MEMORANDUM

SUBJECT: SP21-063; Douglas 234 F6 L1 – Gas and Convenience Store
SP21-064; Douglas 234 F6 L2 - Car Wash
Review Comments 03

SITE PLAN LOT 1
CONVENIENCE STORE
 CHAMBERS AND HESS, PARKER, CO
LANDSCAPE PLAN

1 LANDSCAPE PLAN

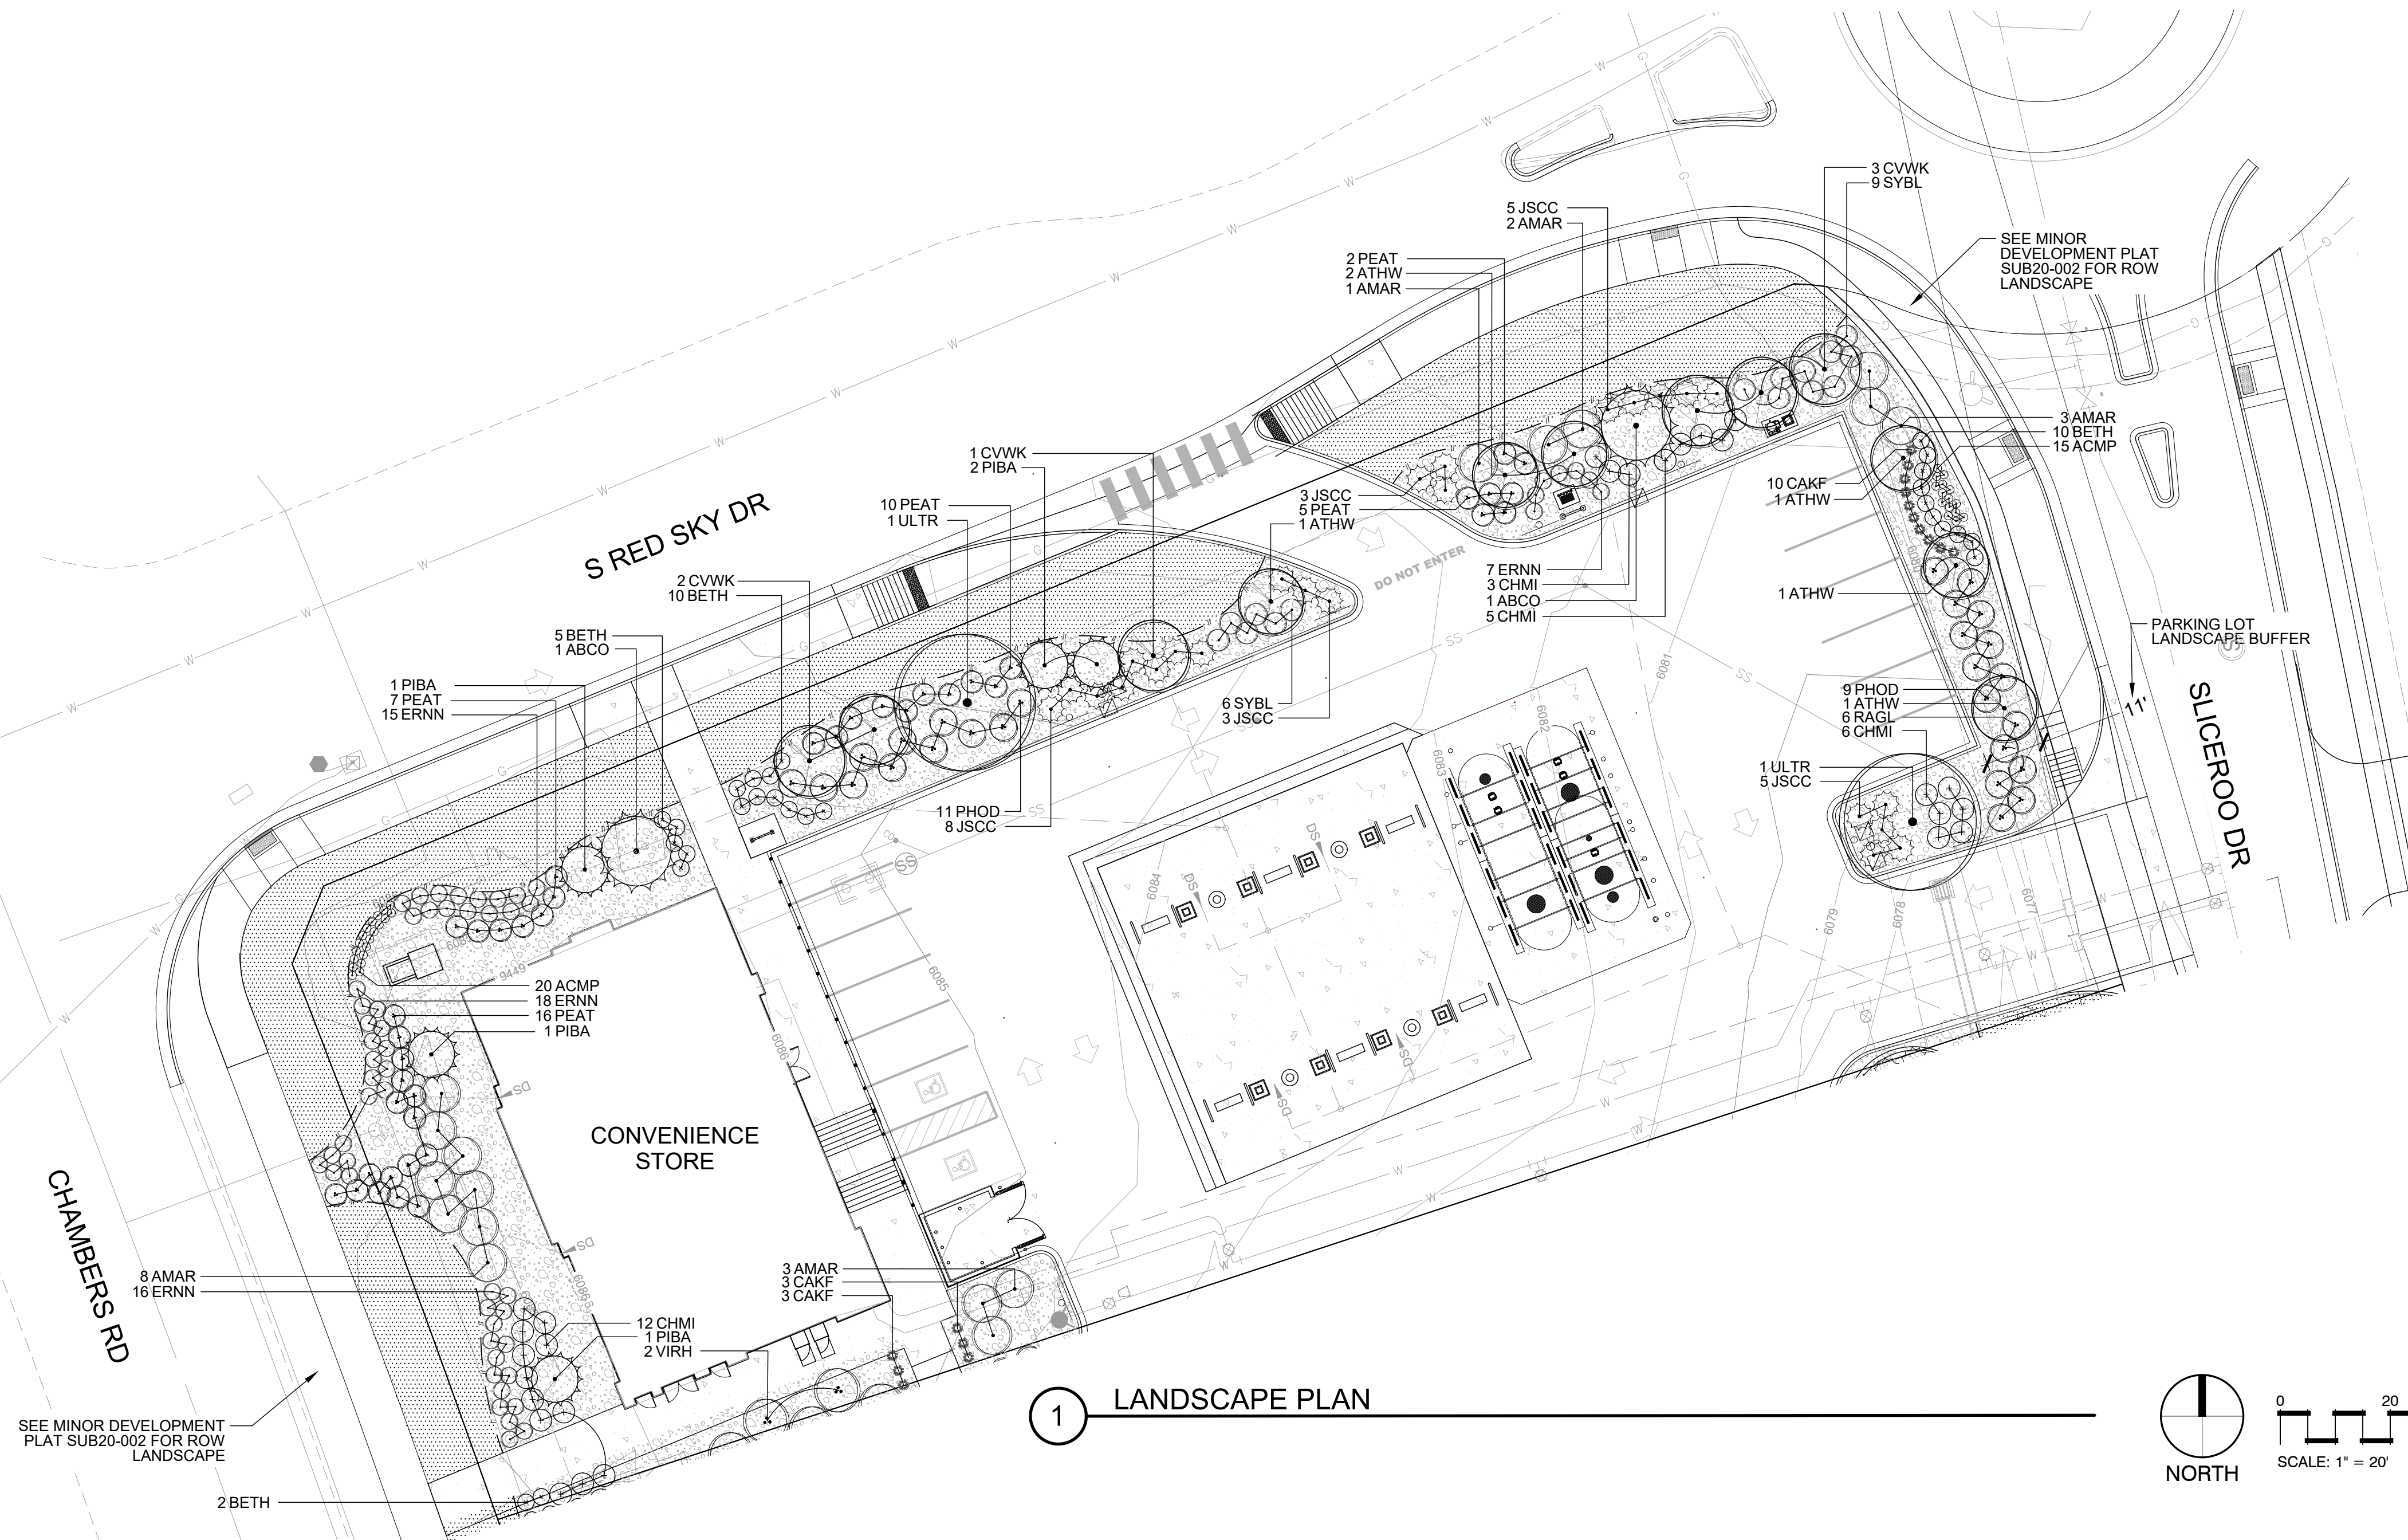
PLANT REQUIREMENT NOTES:
 1. ORNAMENTAL GRASSES AND PERENNIALS ARE COUNTED TOWARD TE'S AS 3 GRASSES = 1 SHRUB.
 When added up, all of your shrubs in this column total 249. When I look at your plant schedule you have 233 shrubs and 16 grasses. Grasses can only be used to replace shrubs and not shrubs that are replacing trees. Also, if you are replacing shrubs with grasses its 3:1 so you would need to have 48 grasses, not 16 (you are replacing on one to one which is not allowed). You would also need to show the grass to shrub replacement in your chart. But again, these grasses cannot replace shrubs which replace trees.

These numbers included grasses and perennials (at a 3:1 ratio). Shrub numbers and grasses have now been separated. Grasses are substituting for shrub requirements only, which has been noted.

LANDSCAPE PLAN

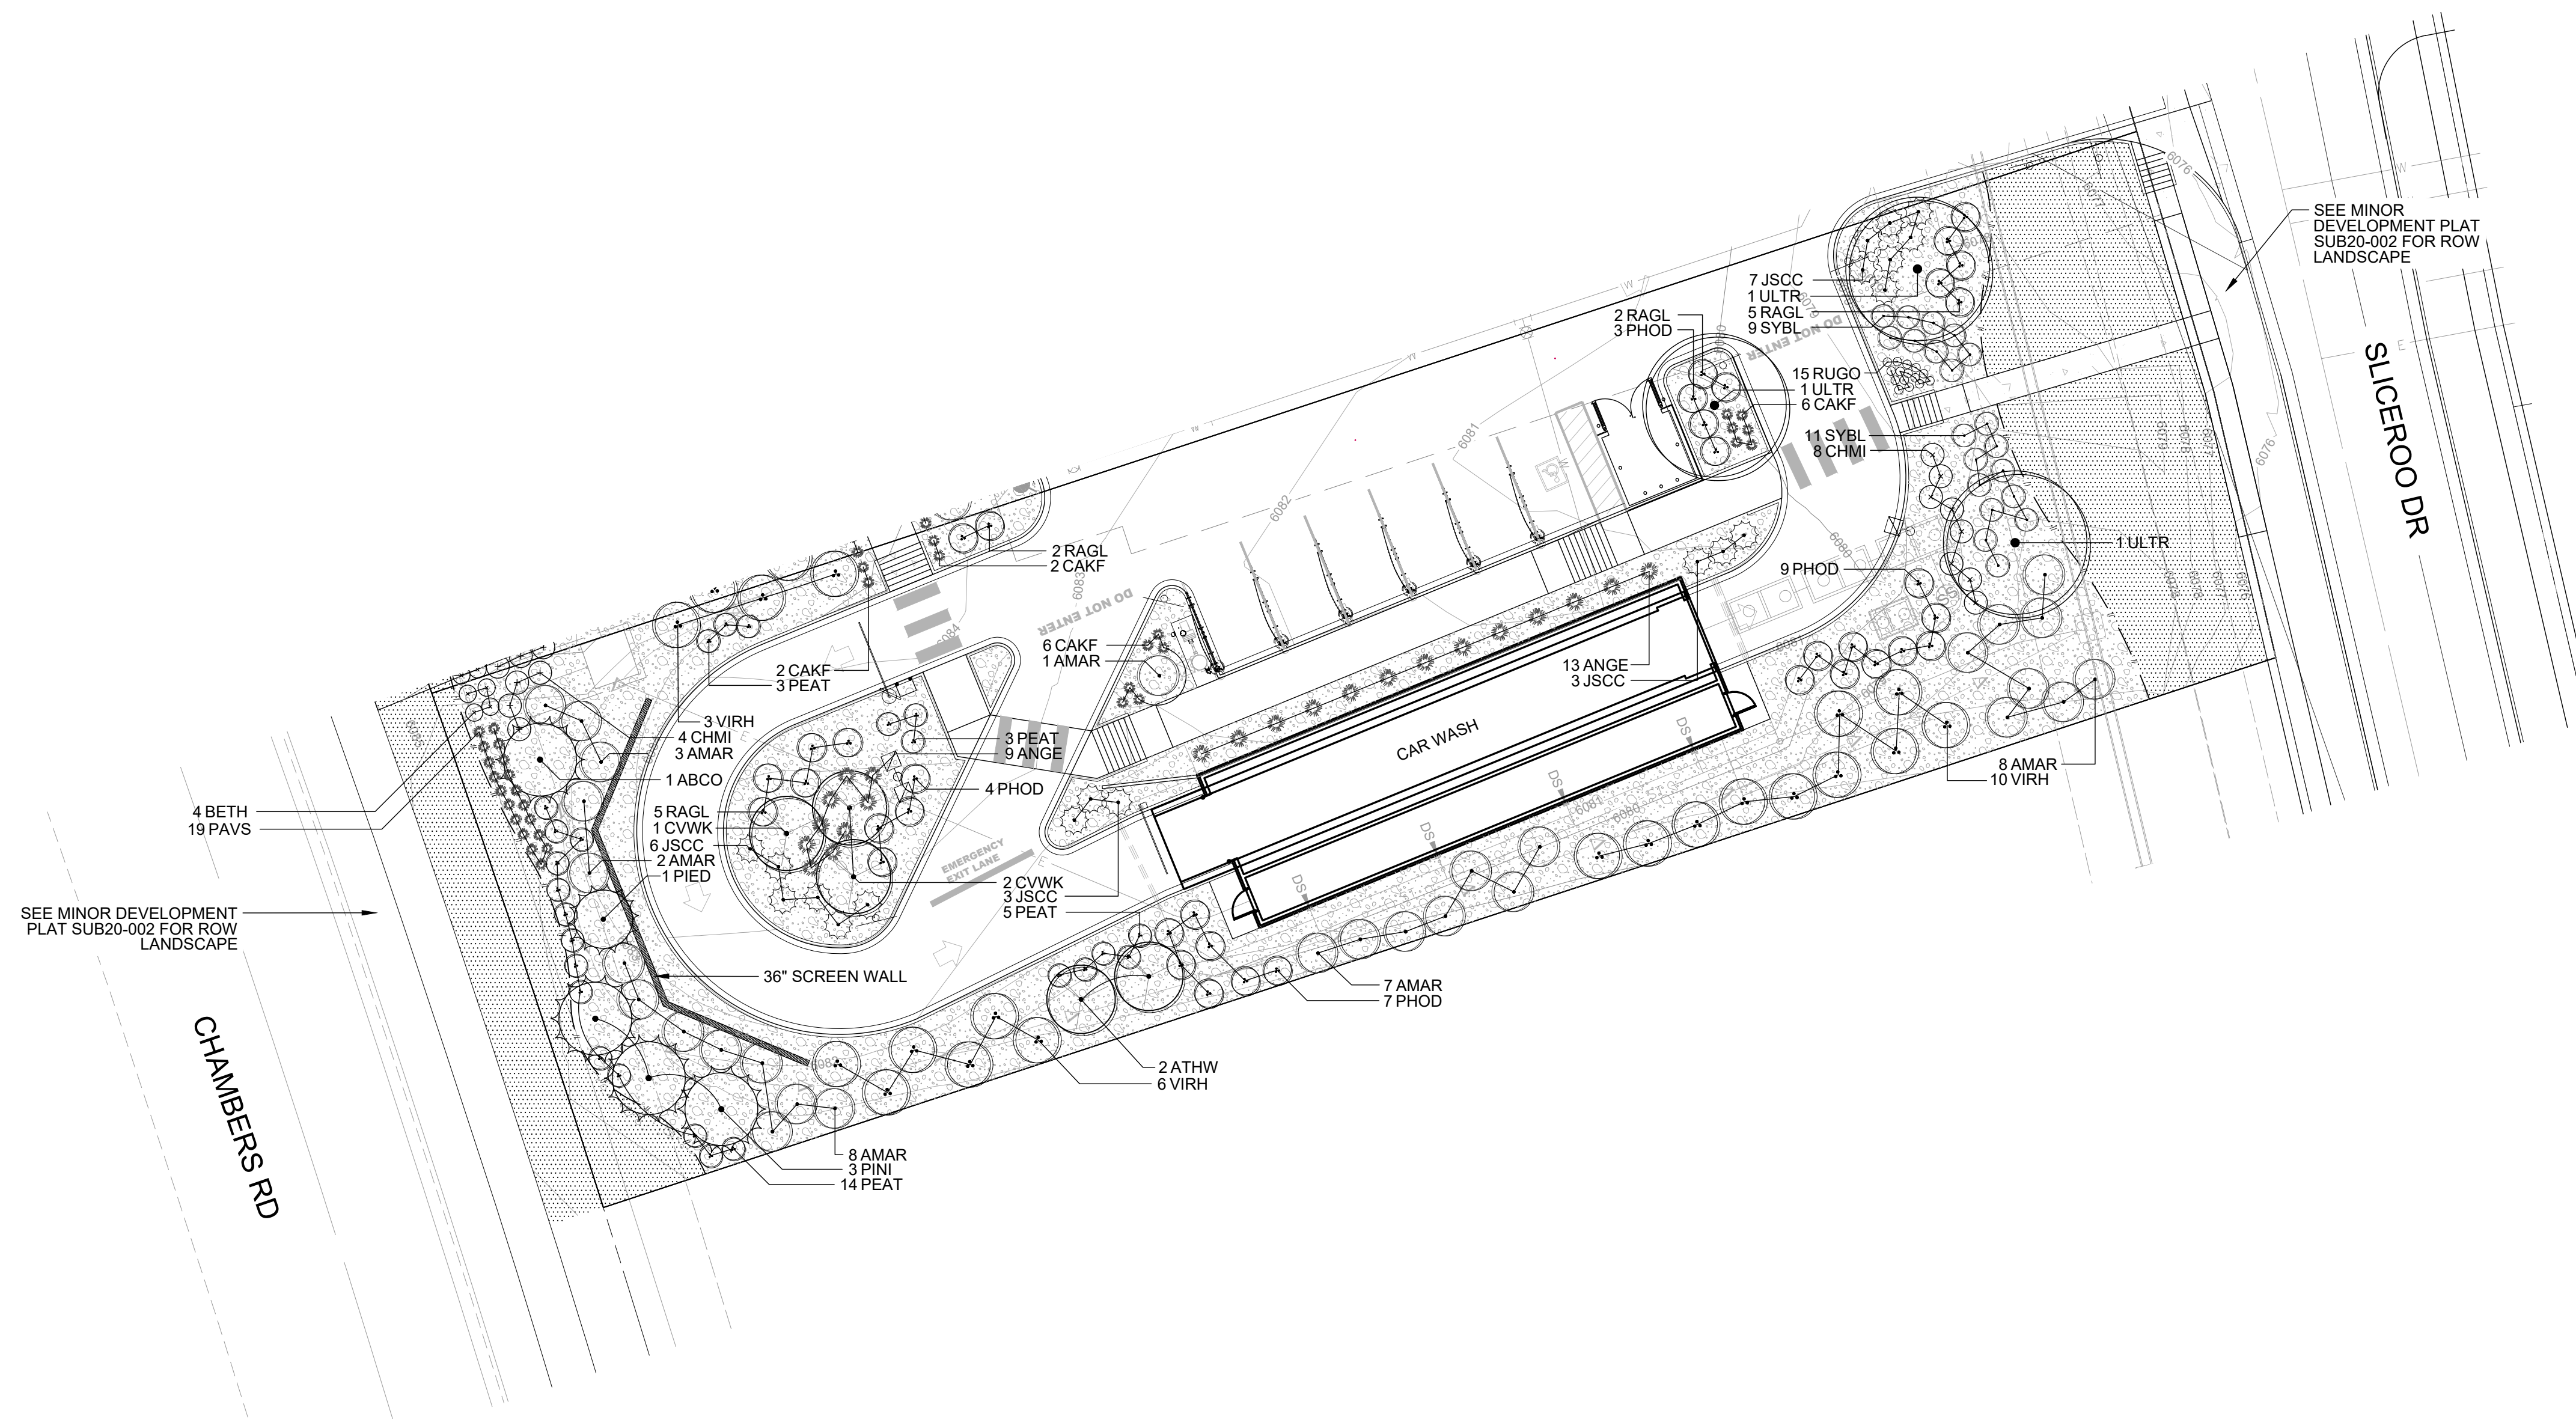
This should be 3 unless you are adding 3 addition TE from the shrubs which should then be shown

This should also state 34

Needs to say Revised/TE's

When added up, all of your shrubs in this column total 189. When I look at your plant schedule you have 165 shrubs. Grasses can only be used to replace shrubs and not shrubs that are replacing trees. Also, if you are replacing shrubs with grasses its 3:1. You would also need to show the grass to shrub replacement in your chart. But again, these grasses cannot replace shrubs which replace trees.

This should be zero-there are no tree equivalents

These numbers included grasses and perennials (at a 3:1 ratio). Shrub numbers and grasses have now been separated. Grasses are substituting for shrub requirements only, which has been noted.

1 Shrub and grass totals have been added
